**Community Environmental Response  
Facilitation Act (CERFA) Report  
Fort Wingate Depot Activity  
Gallup, New Mexico**

**U.S. Army Environmental Center  
Response to Regulatory Comments  
Fort Wingate Depot Activity Draft CERFA Report**

**U.S. Army Environmental Center  
Response to Internal Army Comments (Requested by the State of New Mexico Environment Department)  
Fort Wingate Army Depot Activity Draft CERFA Report**

NO. 2A

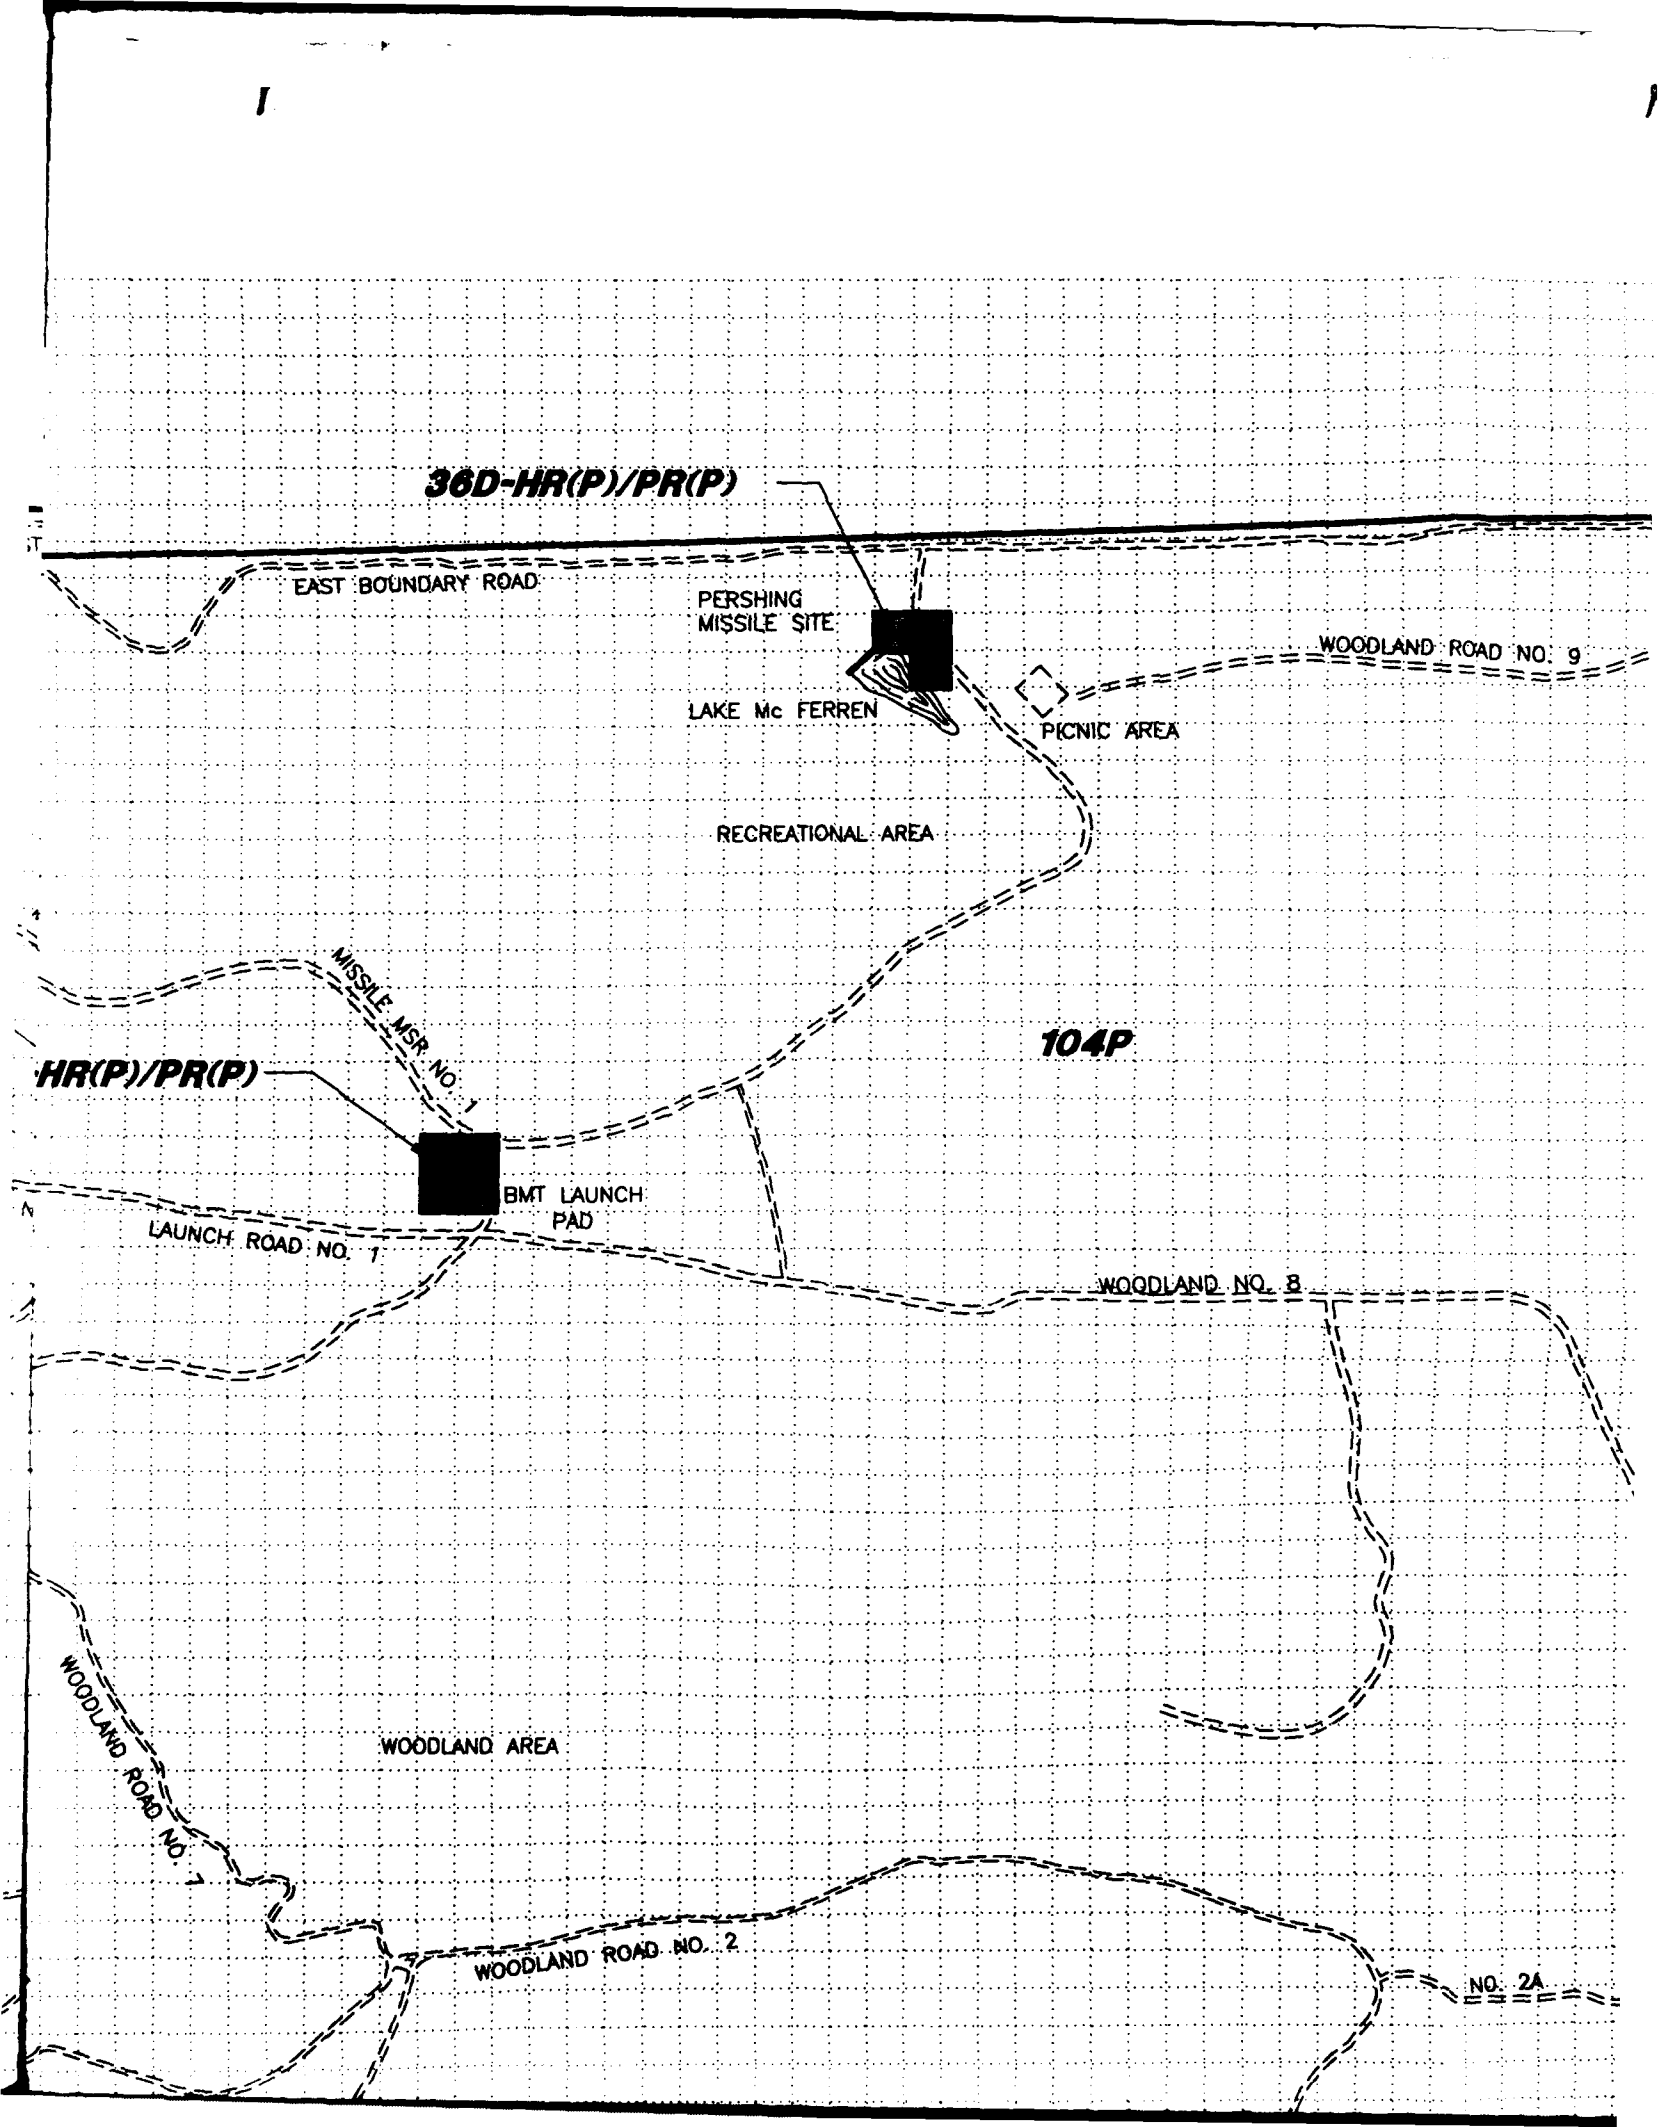
- This Center takes exception to your designation of the former ballistic launch sites. These areas were evaluated in the RI/FS and found not to be areas of environmental concern. You disqualify them due to potential hazardous and petroleum releases (Sheet 2 of 4). This is not accurate.

- This Center takes exception to your designation of the Old OB/OD areas (Sheet 2 of 4). What is the basis for the "HR" designation of these areas?

M.K. Bond/CMP	DATE 12.07.93/04.09.94	CLIENT APPROVAL		
1" = 300'	W.O. No. PM307.70.01/1307-1	ISSUED FOR	DATE	SHEET 3 OF 4

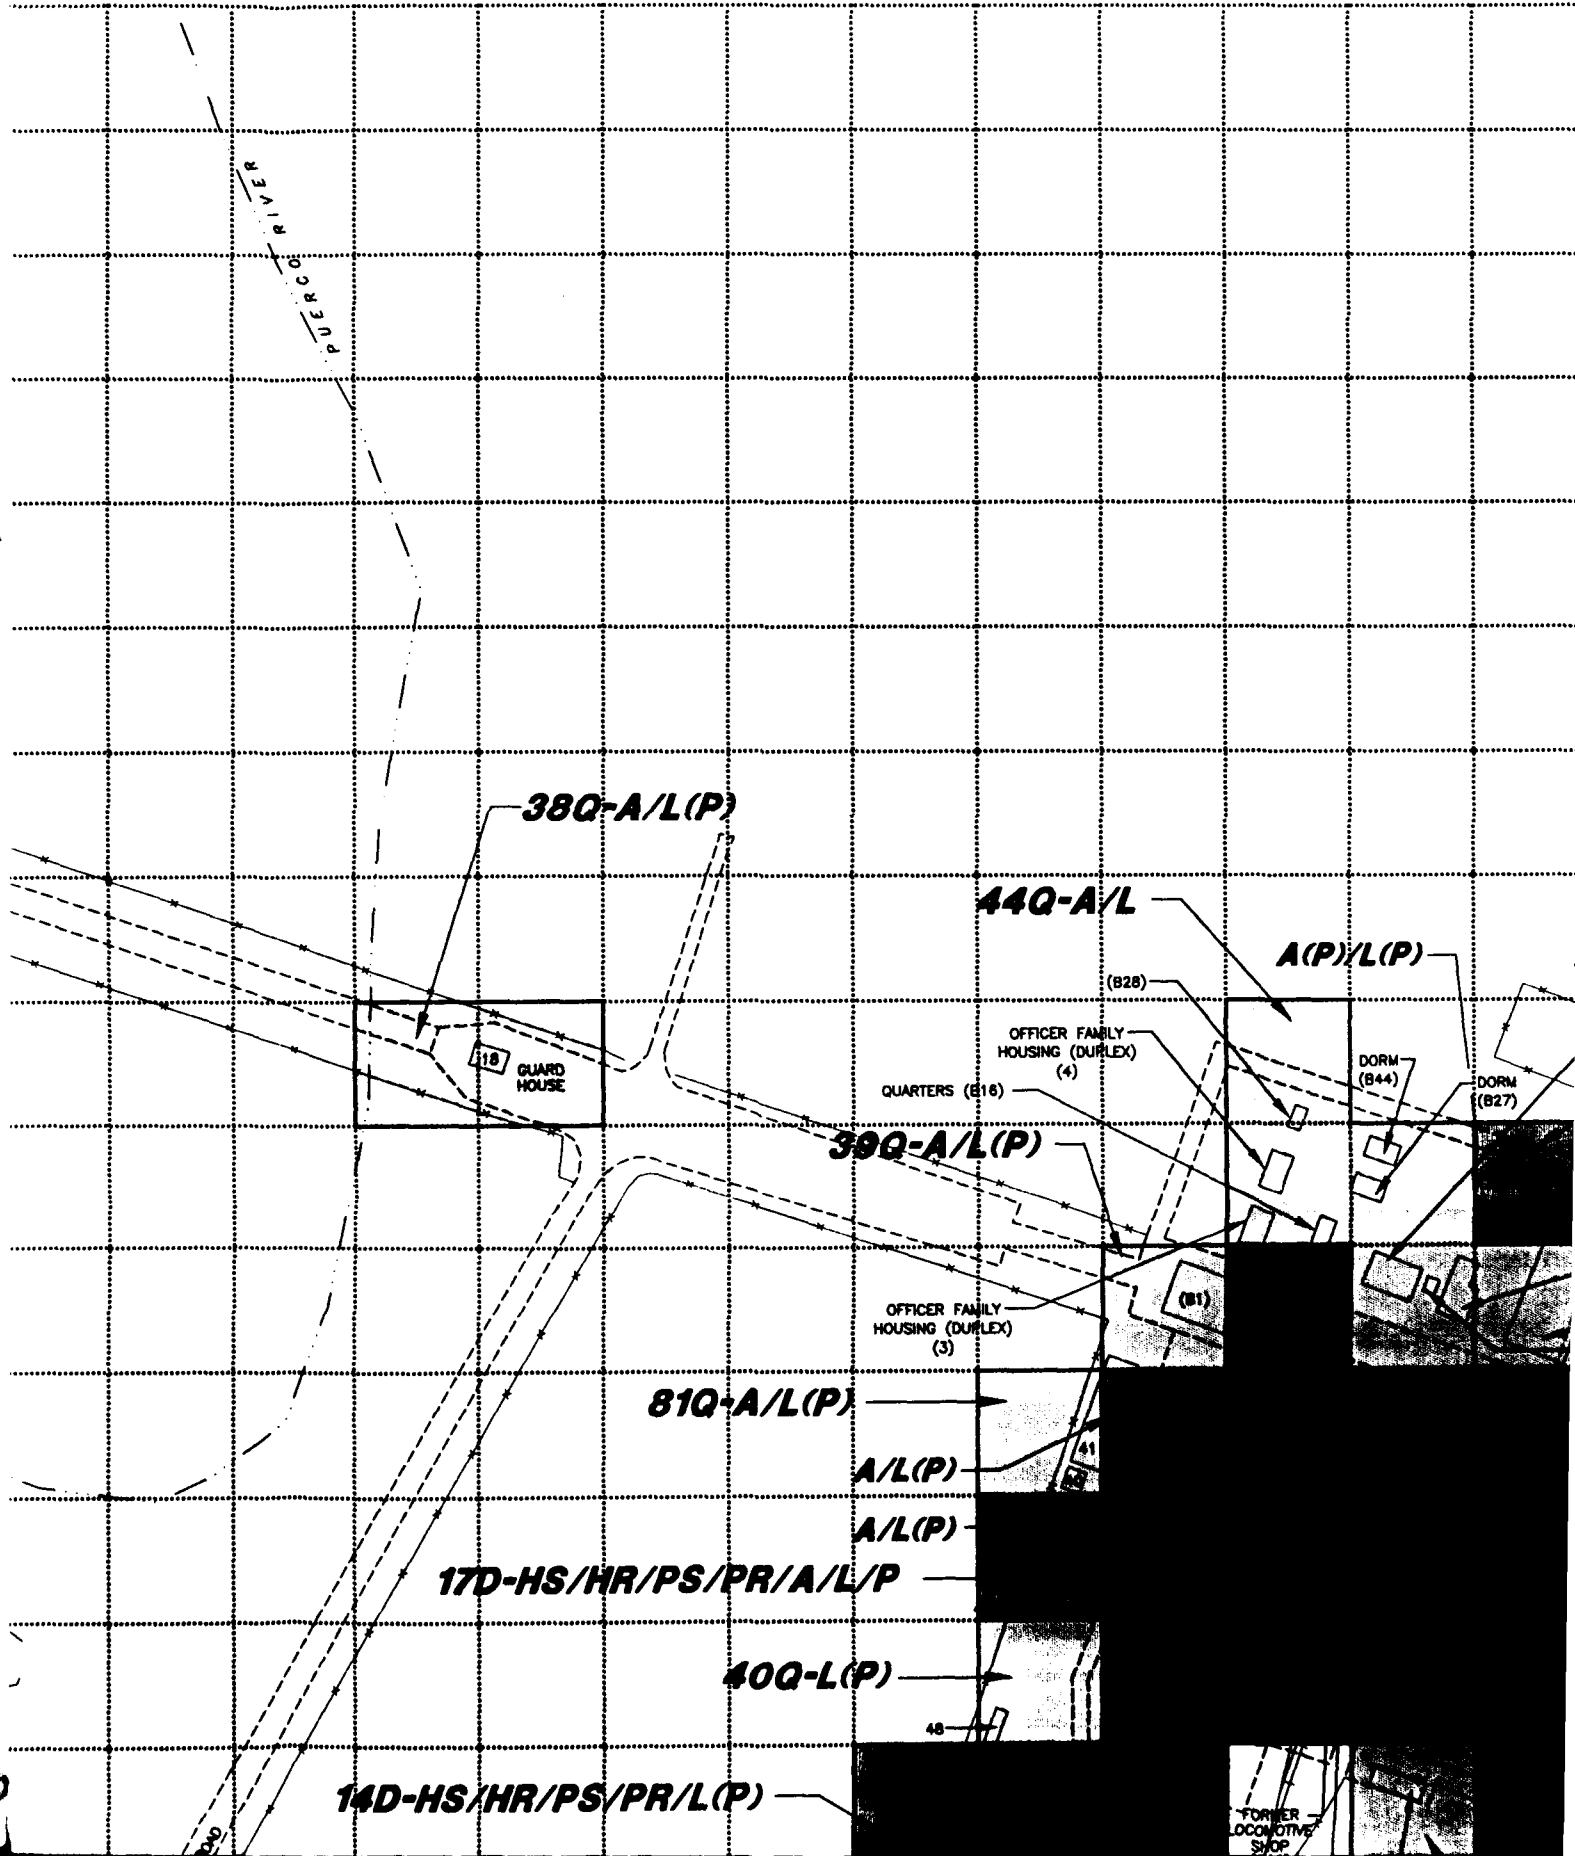
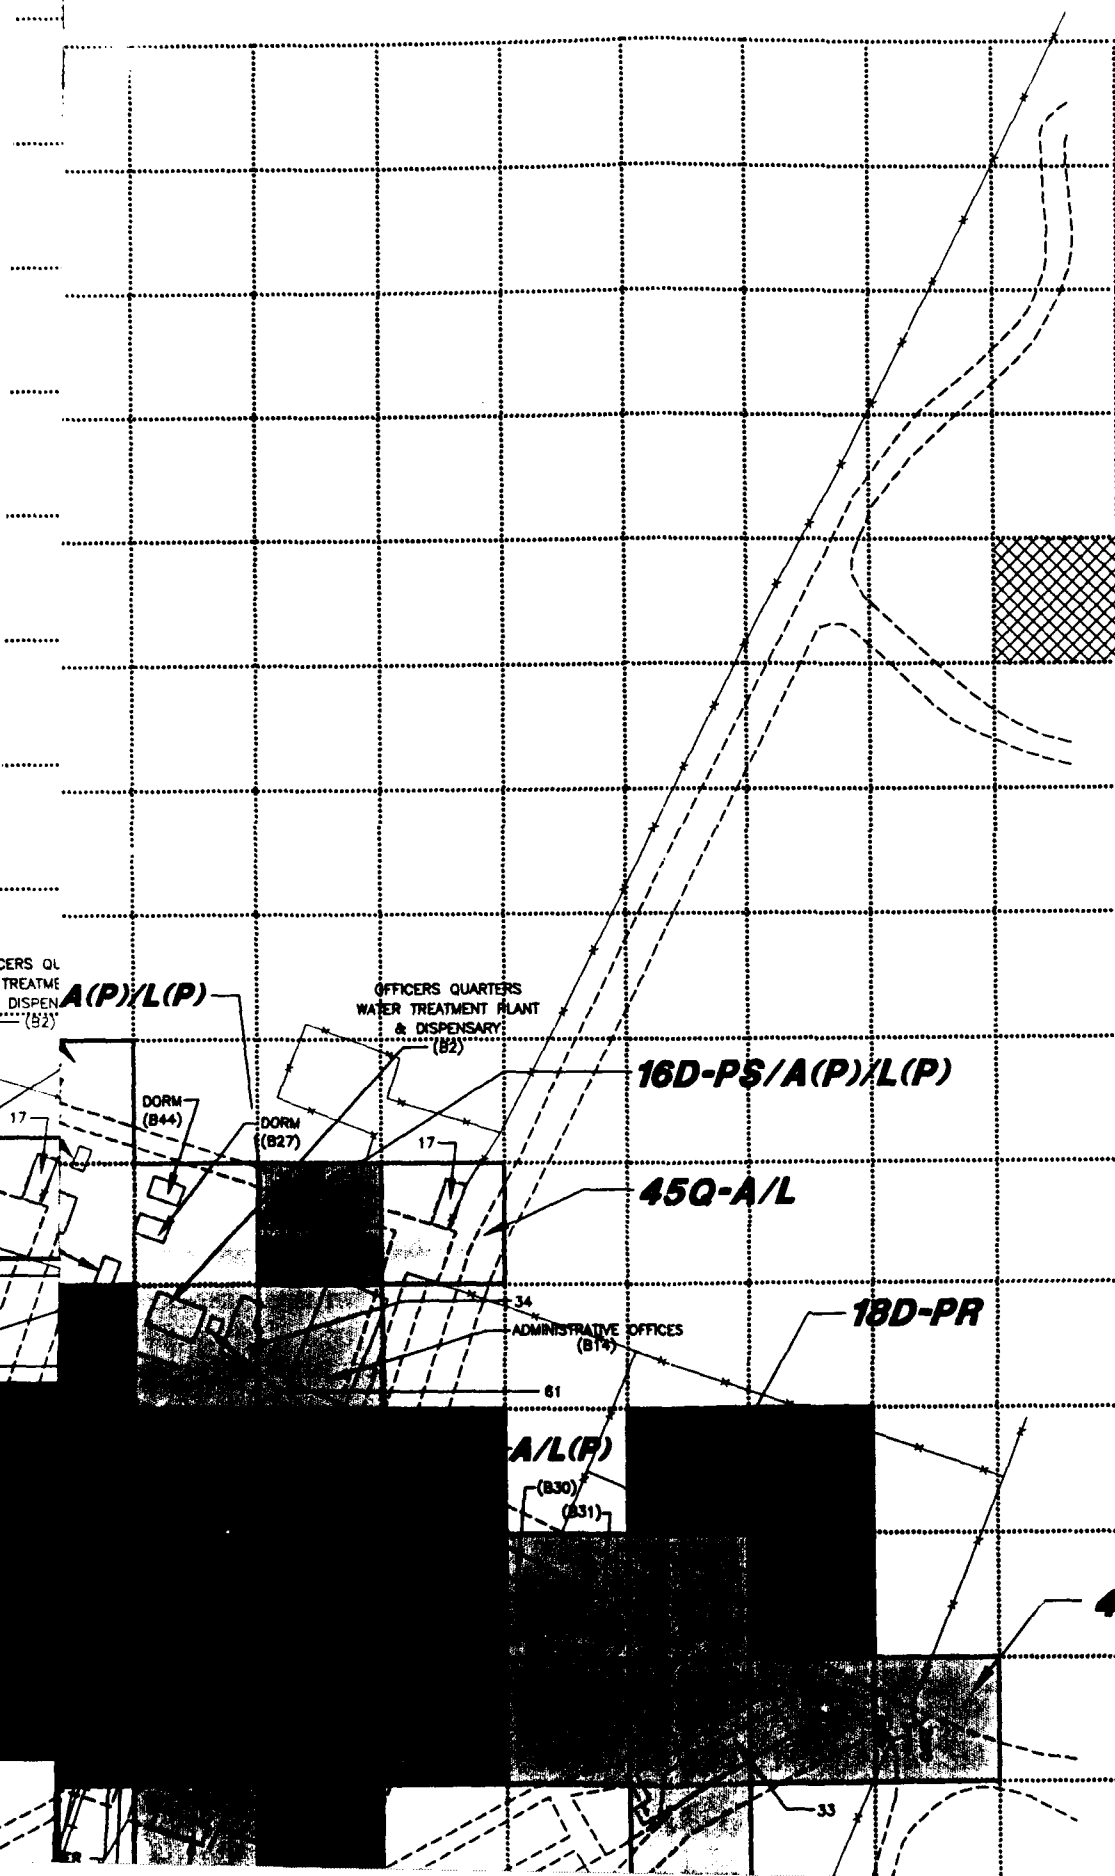
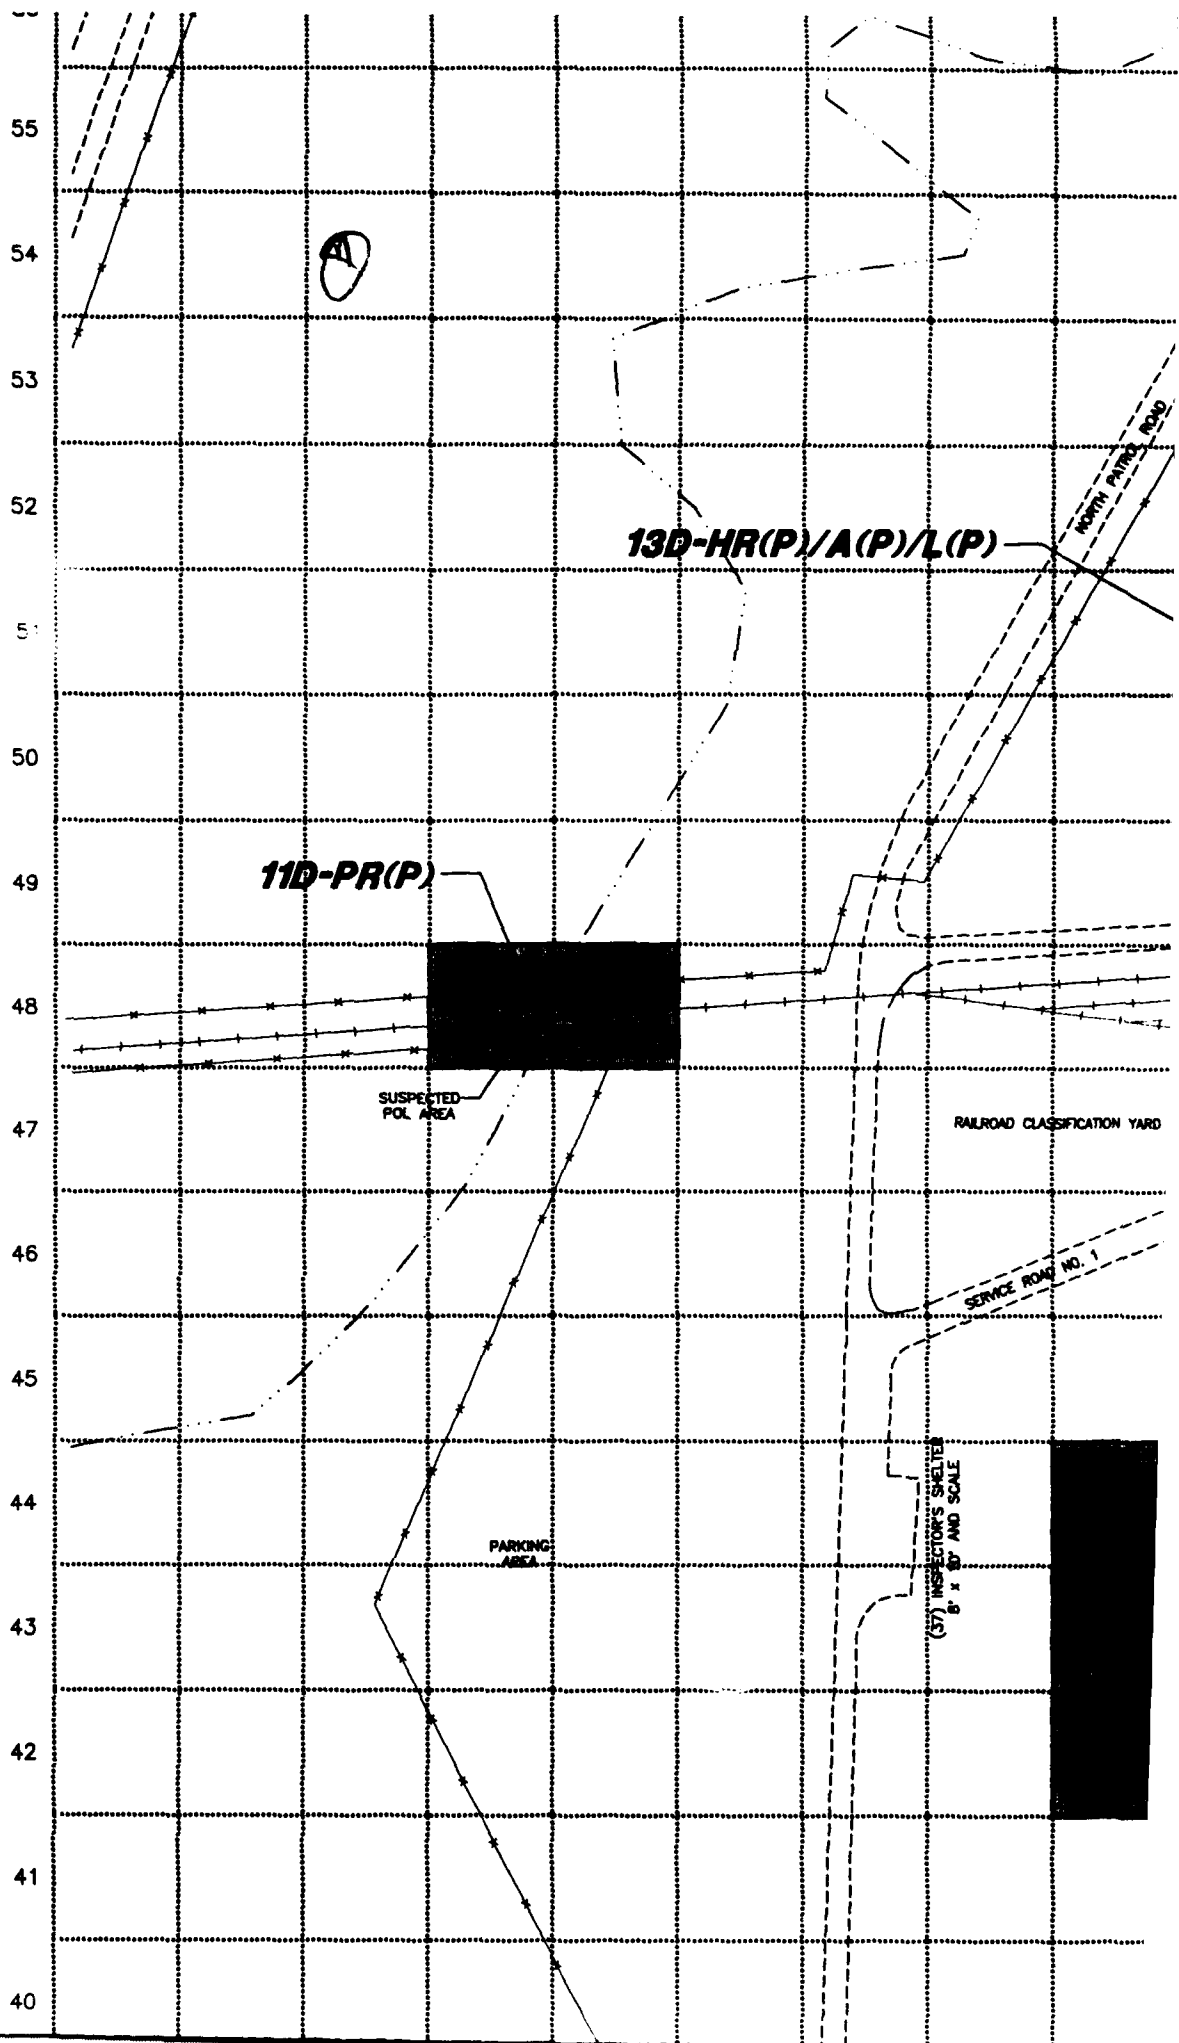
- You must classify the fluorspar storage area found on Sheet 3 of 4. In addition, you fail to acknowledge the buildings in the Administration Area currently under lease for Native American food distribution services. Given the category definitions for this investigation, doesn't this area qualify as a CERFA Excluded parcel? Coordinate with the RI/FS team for this information.

- Sheet 3 of 4 needs to be revised to accurately represent the data from the RI/FS Report.
